**RECALL  
BULLETIN:  
110520FRV**

**PRODUCT(S)  
AFFECTED:**  
Bounder,  
Bounder  
Classic, Storm,  
Southwind,  
Terra, built  
on Ford 53  
Chassis

**SUBJECT:**  
Routing the  
Wire Harness  
Away from  
Engine Manifold  
Heat Shield

**ISSUE DATE:**  
July 2011

**(Wire Harness Routed Along Chassis Rail)**

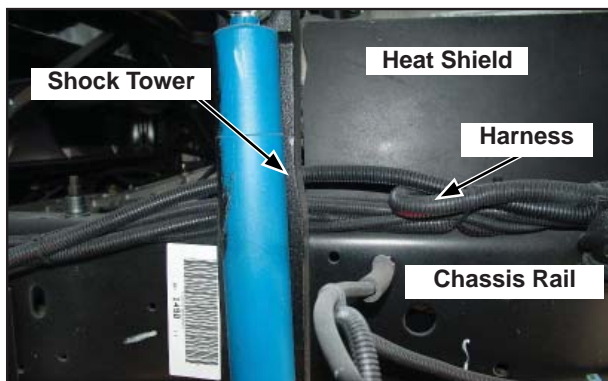
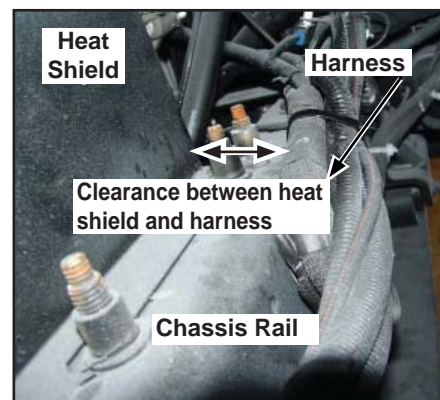
On motor homes affected by this recall, a wire harness routed under the motor home can contact a heat shield located next to the passenger side engine exhaust manifold. The heat can transfer from the heat shield to the harness and can melt or otherwise damage the wiring. A damaged wire harness can result in an electrical short, which can result in intermittent operation of electrical systems, vehicle "shut down" and/or lead to a fire, and may result in loss of vehicle control, injury or death.

3. Locate the 12-volt wire harness routed under the motor home near the front passenger side wheel. The harness may be routed along the frame rail, or secured to the underside of the floor. Tug firmly on the wires to determine if they have the potential to contact the heat shield:

4. Remove and discard existing fasteners as needed to facilitate correction of the wire harness routing. Use new insulated loop clamps and heavy duty wire ties as required to secure the wire harness in a manner that prevents it from making contact with the heat shield. Loop clamps must be fastened securely to a stable component such as a chassis crossmember or the structural tube supporting the floor.

- Turning the front tires toward the passenger's side will facilitate access to the repair area. If this is done, ensure the ignition key is removed before resuming work.
- Heavy duty wire ties are to measure a minimum of 0.3125" wide by 0.075" thick.
- Smaller wire ties may be used only to be used to secure one wire or group of wires to another.
- Due to possible differences in the routing of the wire harness, it may have originally been secured along the frame rail or to the underside of the floor. Refer to the photos in Figures 1a and 1b to correct the routing of a wire harness that is fastened along the frame rail. Refer to the photos in Figures 2a and 2b to correct the routing of a wire harness that is fastened to the underside of the floor.
